From: Mess, Camie
Sent: Tuesday, February 27, 2018 12:11 PM
To: 'keith@rosneyarchitects.com'
Cc: Werner, Jeffrey B
Subject: BAR Action- February 21, 2018 - 540 Park Street

BAR 18-02-03
540 Park Street
Tax Parcel 520183000
Lynn and Tobias Dengel, Owner/ Keith Scott and Julie Dixon, Applicant
New roof and gutters

**CITY OF CHARLOTTESVILLE
BOARD OF ARCHITECTURAL REVIEW
STAFF REPORT
February 21, 2018**

BAR 18-02-03

Proposed Representative Eave Section

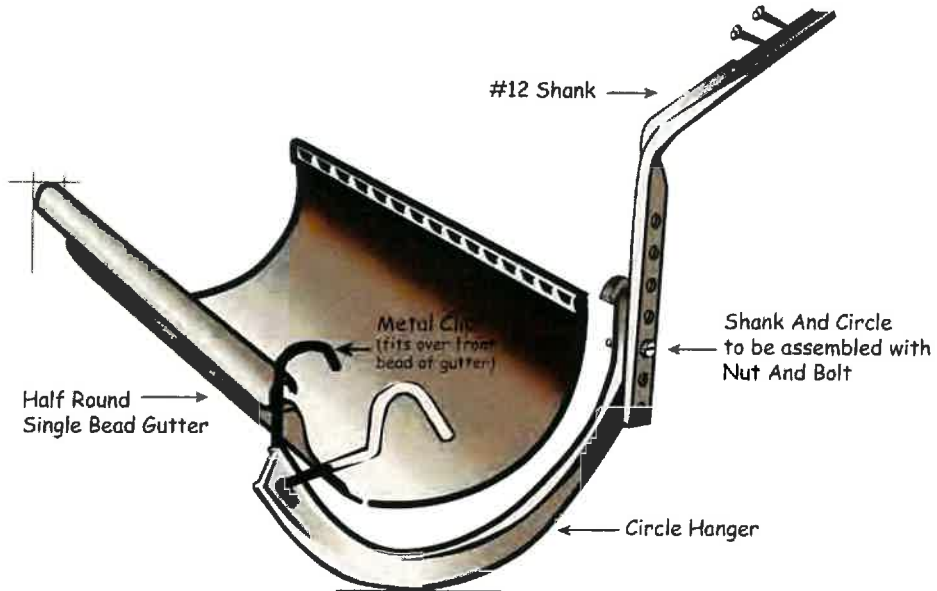
Schwarz moved: Having considered the standards set forth within the City Code, including City Design Guidelines for Rehabilitation, I move to find that the proposed new copper roof and copper gutter system satisfies the BAR's criteria and guidelines and is compatible with this property and other properties in the North Downtown ADC district, and that the BAR approves the application with the following modification that you find a way to paint the downspouts to minimize visibility and, as much as possible, locate downspouts to minimize visibility, especially at prominent corners . Earnst seconded. Approved (5-0).

The material change from painted metal standing seam to a copper standing seam with matching roof pans complies with the ADC Guidelines. However, the removal of the Philadelphia Gutter system with downspouts to be replaced with 6" copper half round gutters mounted on eaves with 4" copper downspouts is something the BAR will need to discuss, especially since these aesthetic changes would be visible from the street.
